Project Verification Report

COVER PAGE Project Verification Report Form (PVR) BASIC INFORMATION Name of approved GCC Project Verifier / Reference No. Carbon Check (India) Private Limited. /GCCV004/01 (also provide weblink of approved GCC Certificate) http://globalcarboncouncil.com/wpcontent/uploads/2021/10/carbon-check-india-private-limitedccipl.pdf ☐ Individual Track¹ Type of Accreditation CDM Accreditation Valid from 28/03/2019 to 01/06/2024 ISO 14065 Accreditation https://cdm.unfccc.int/DOE/list/DOE.html?entityCode=E-0052 Valid from 28/06/2021 until 27/06/2024 https://nabcb.qci.org.in//accreditation/ghg/ghg004.php **Approved GCC Scopes and GHG** GCC Scope **Sectoral scopes for Project** Green House Gas (GHG# - ACC) Verification Environmental No-harm (E+) Social No-harm (S+) Sustainable Development Goals (SDG+) **GHG Sectoral Scope** 1. Energy (renewable/non-renewable sources) (CDM TA 1.1, 1.2) Validity of GCC approval of 08/03/2023 to 31/05/2024 Verifier Title, completion date, and Kovanlık Reg. ve HES Version number of the PSF to which this report applies Version 10,

GTE Karbon Sürdürülebilir Enerji Egitim Danışmanlık ve Ticaret A.Ş has appointed the DOE, Carbon Check (India)

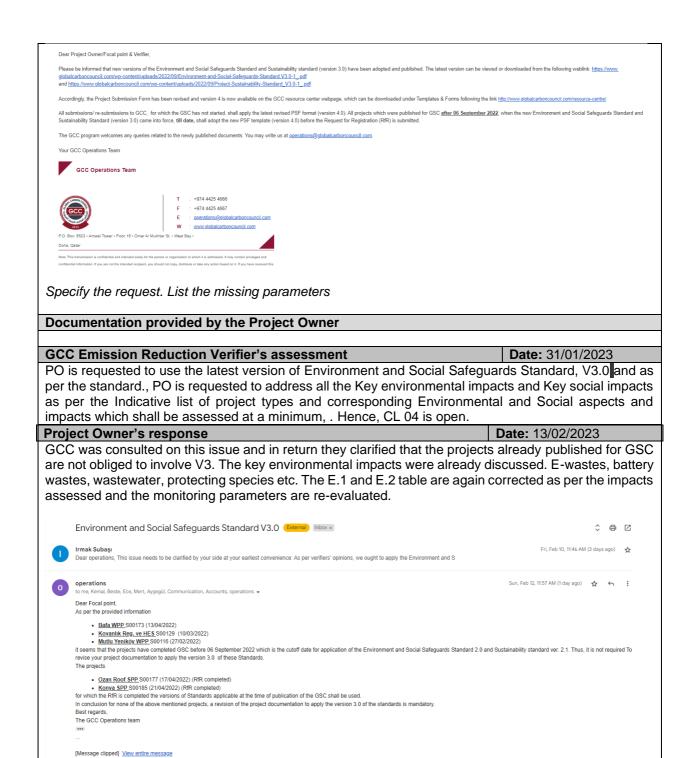
In SDG 7, it has been mentioned as "by the utilization of biomass as a renewable energy source". In SDG 13 and 9, it is mentioned that project uses wind energy. PO is requested to clarify the same. Also, Commissioning documents folder provided is found to be empty in SDG 7 & 9.

No employment records of women were found in the credible evidence of SDG 8. Further, PO is requested to follow the latest Environment and Social Safeguards Standard V3. Hence, CL 04 is open. Date: 07/01/2023

The sentences for SDG 7-8-9 are revised.
